2.0 PROXIMITY AND NOISE

**Glen Dhu Power-Wind Project
Registration Document
Addendum**

**Figure 2.3
Estimated Turbine Sound Levels**

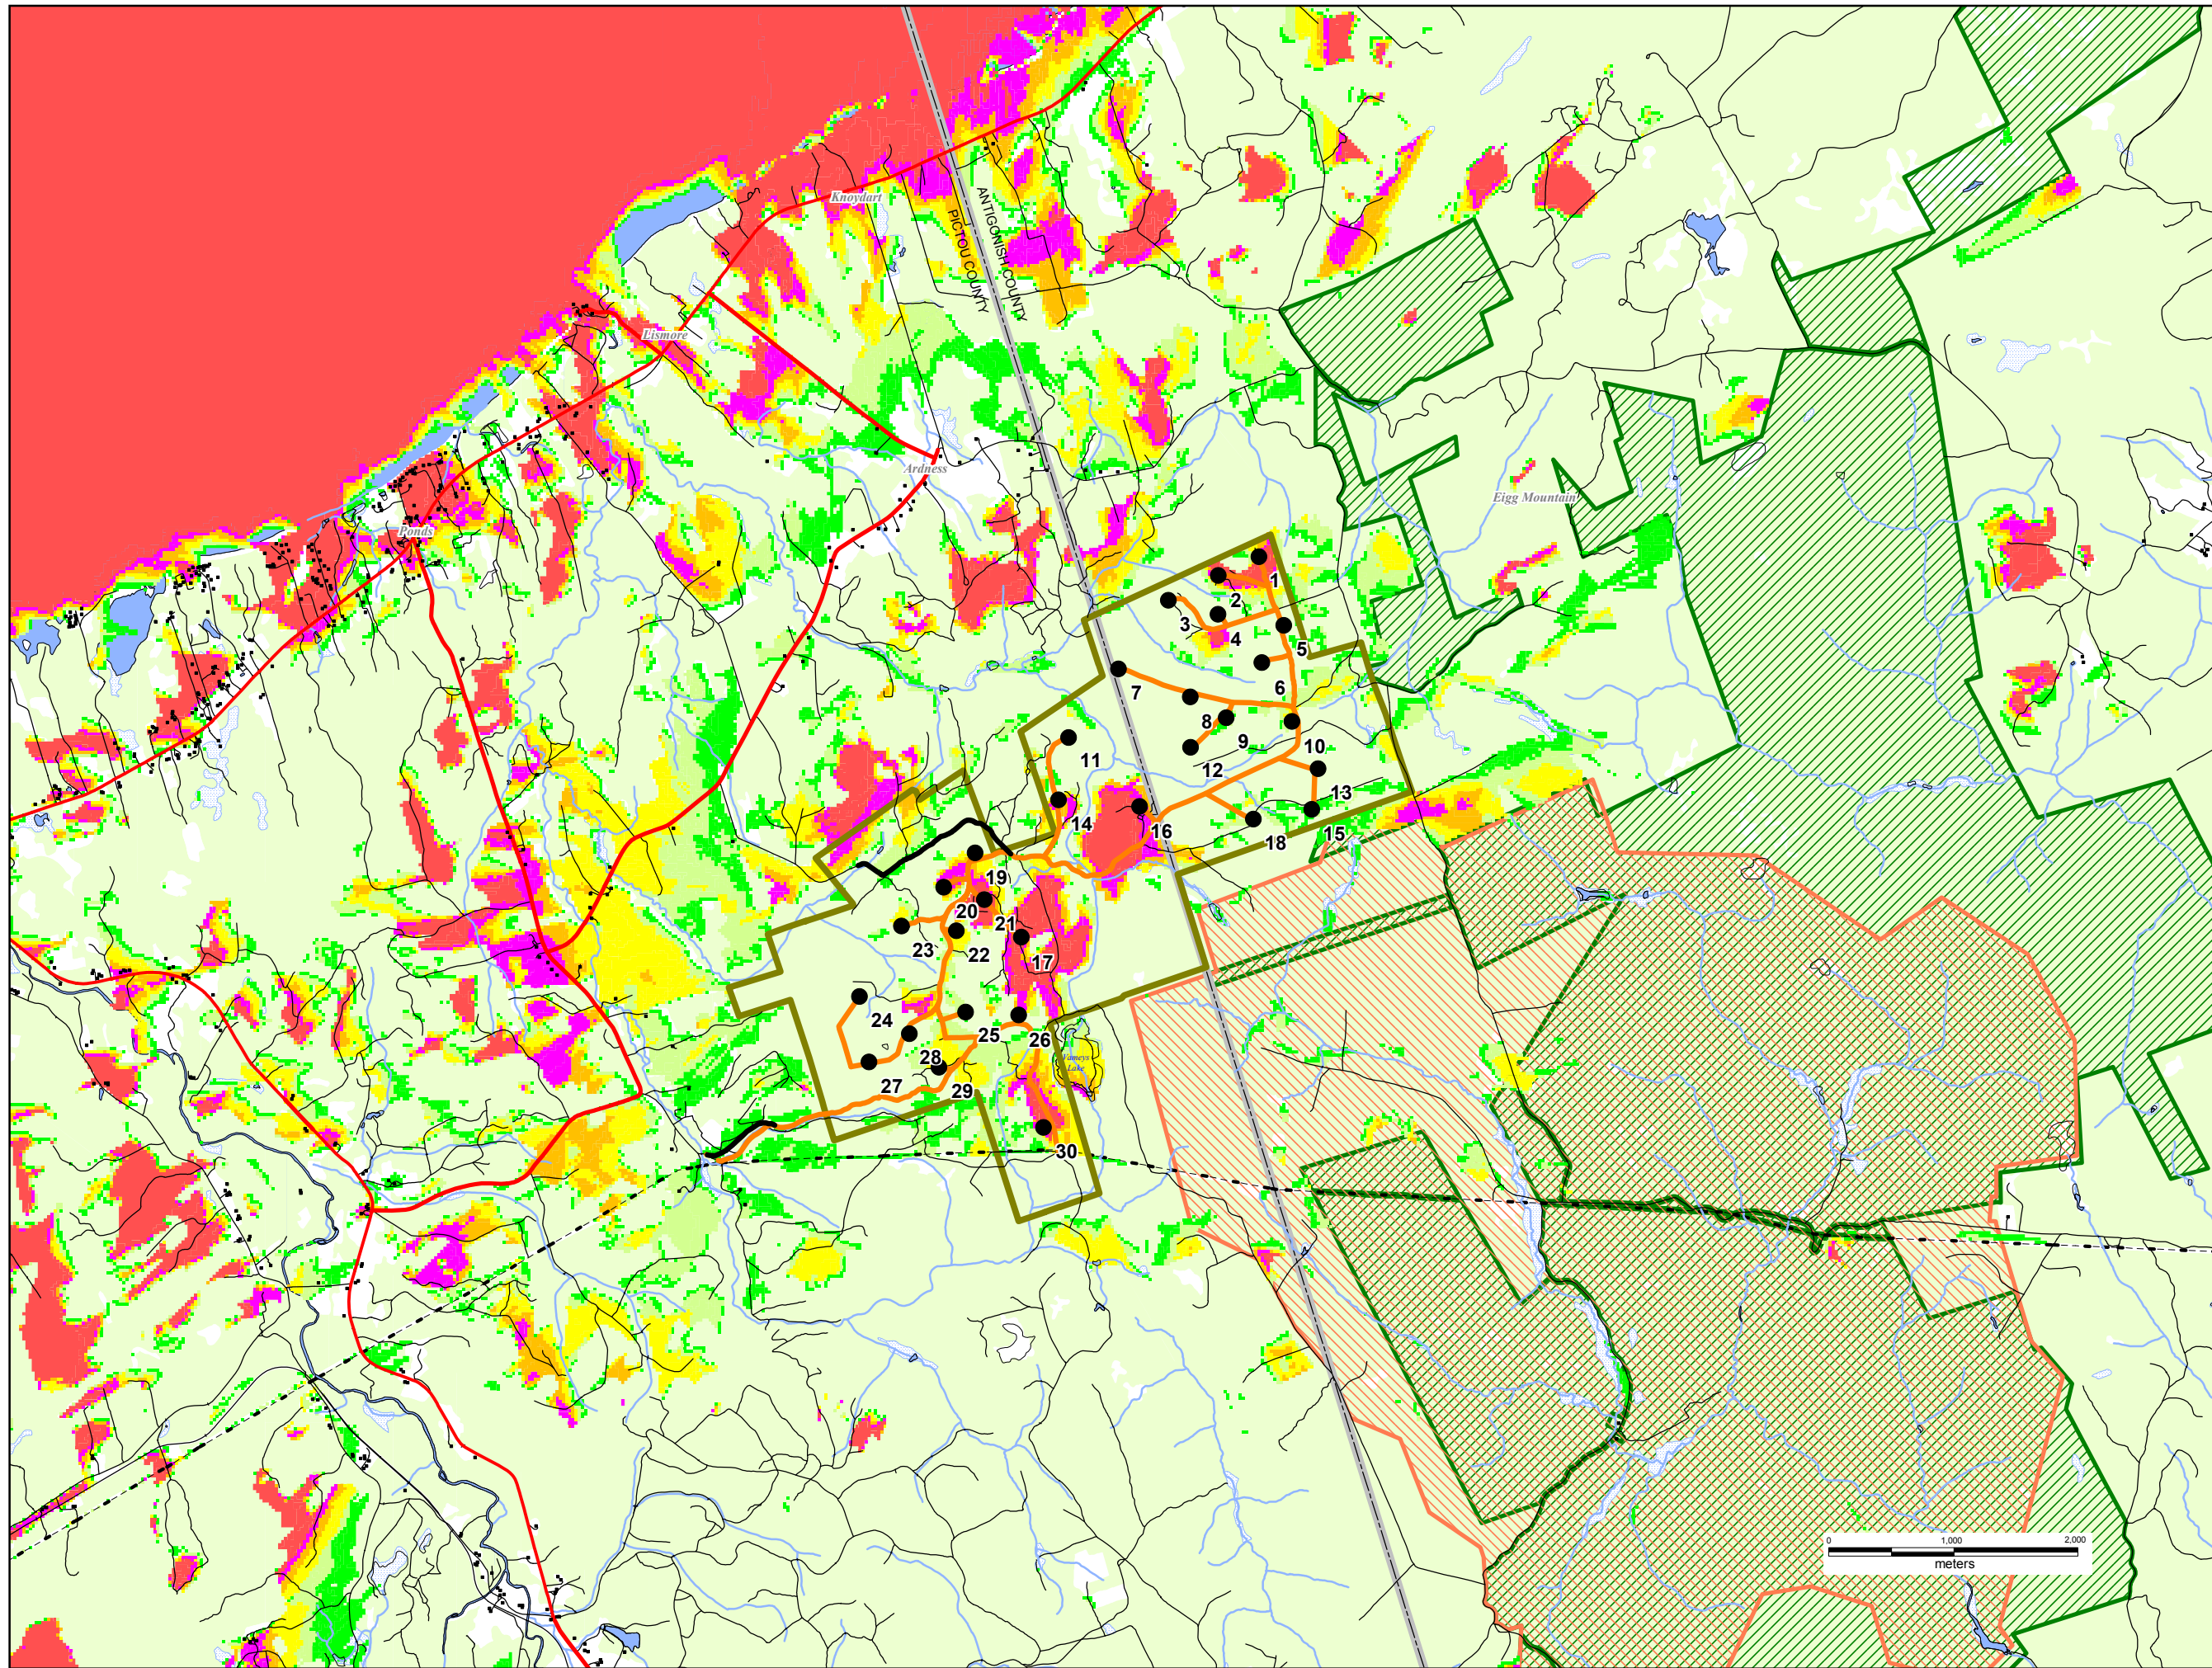
A noise model was used to assess potential sound levels around the turbine sites. This model is an ISO approved model and used international standards to assess potential noise levels. Figure 2.3 shows Estimated Turbine Sound Levels from modeling of the revised locations. Figure 2.3 replaces Figure 5.5 of the EA Registration Document. Details of the model and the assumptions used are described in Section 2.2. All residences fall outside the 40 db(A) zone which is considered to be typical of background sound levels. All non-participant residences fall outside the 35db(A) noise isoline. The model assumptions are provided in Appendix E.

The sound level module uses 3 dimensional (3D) turbine location data, wind data, digital topography and other physiographic features. The output report containing the assumptions used in this model is attached in Appendix E. The model output provided noise isolines which are shown in Figure 2.3, Estimated Turbine Sound Levels.
